PHILADELPHIA ELECTRIC COMPANY

Subject: Limerick Generating Station, Units 1 & 2
Information for Materials Engineering Branch (MTEB)
Regarding SER Confirmatory Issue #12 - Preservice
Inspection (PSI) Program

Attachments: 1) Limerick Unit 1 PSI Relief Request No. 6, Rev. 1
2) Limerick Unit 1 PSI Relief Request No. 13, Rev. 1
3) Limerick Unit 1 PSI Relief Request No. 16, Rev. 1
4) Limerick Unit 1 PSI Relief Request No. 17, Rev. 0
Additional Information
5) Limerick Unit 1 PSI Relief Request No. 25, Rev. 0
6) Limerick Unit 1 PSI Relief Request No. 26, Rev. 0
7) Limerick Unit 1 Component Summary Table, Rev. 1

nes NUCLEAR ENERGY SERVICES	
SYSTEM NO. 10	TITLE PHR PUMP BODY WELDS AND SUPPORT
REV: 2	FIG. NO. C1-27
BY: RP APP: CJZ	DATE: 8-12-81 DATE: 11-24-81
PROJECT: 5551 LIMERICK UNIT 1	
NOT TO SCALE

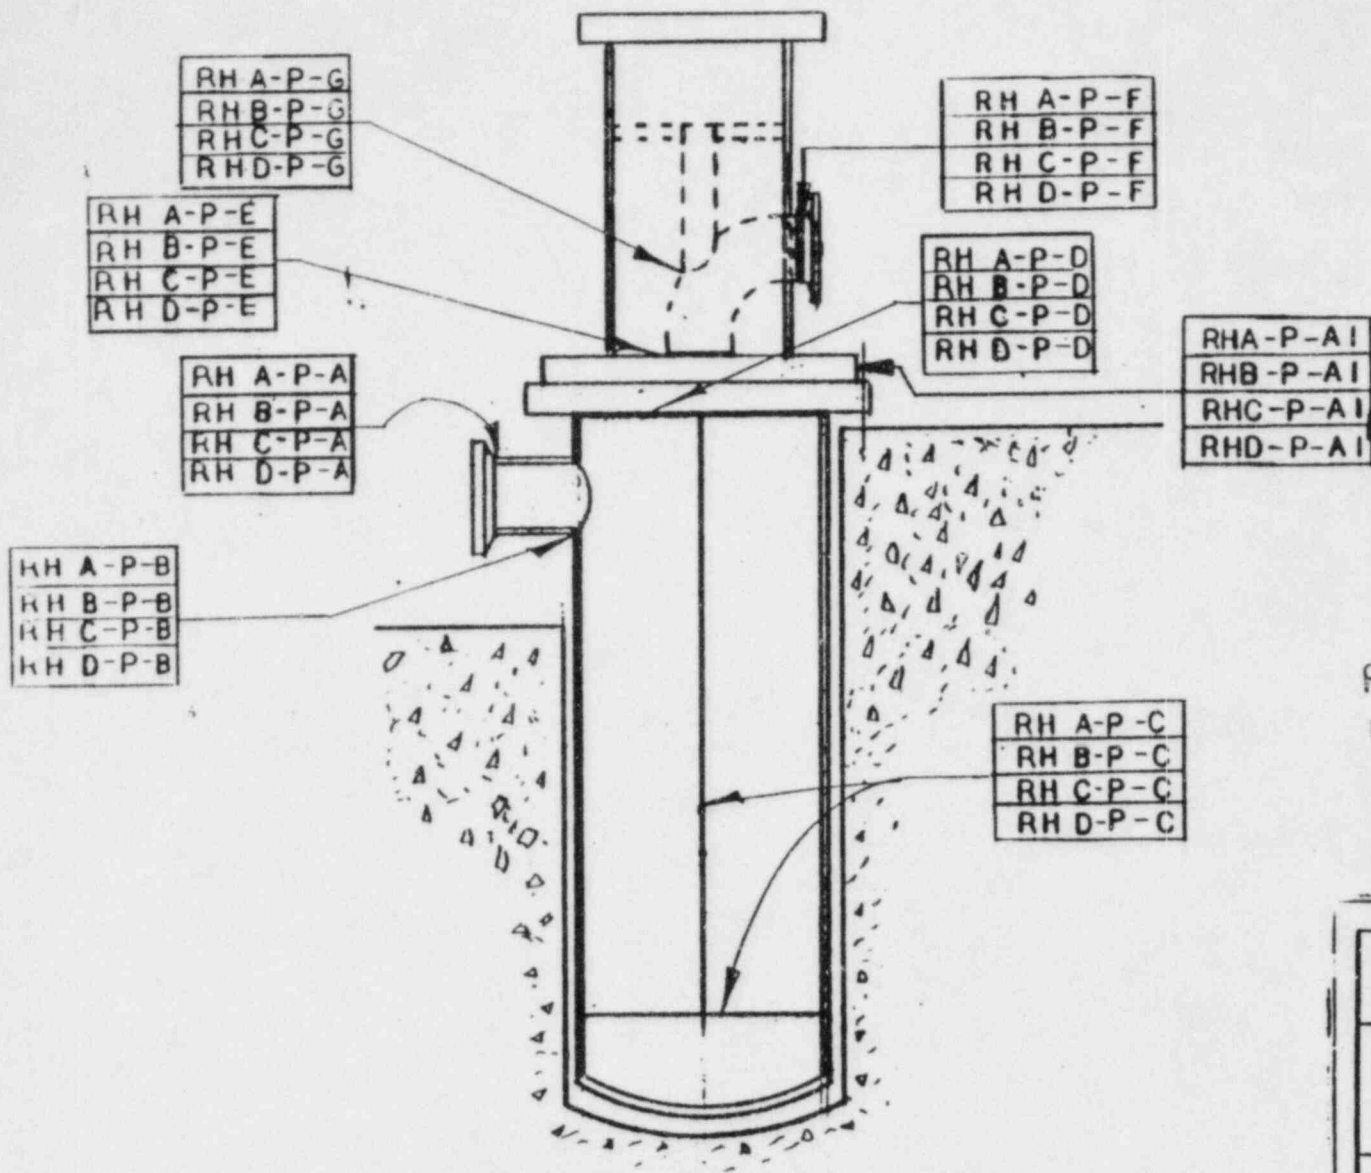
17. Class 2 Pressure Retaining Welds in Pumps
Code Item No. C3-1, Category C-F

1. Weld identification figures from the Preservice Program Plan, 801558 for both the RHR and Core Spray pumps.
2. Excerpts from the Core Spray pump Owners Manual (including General Arrangement Diagram) which provide general design notes for the pump foundations. These notes are typical of both RHR and Core Spray Pumps.
3. Photographs (3) showing the pump foundation arrangement at the inlet nozzles for both the RHR and Core Spray pumps.

Inservice inspection of those pump shell welds that are encased in cement must be deferred until such time that the pump is removed for maintenance. Either visual, surface or volumetric examinations may be performed depending on ALARA considerations and equipment availability. Visual examinations from the exterior will be performed during system pressure tests. Shell leakage can be detected at the foundation construction joints.
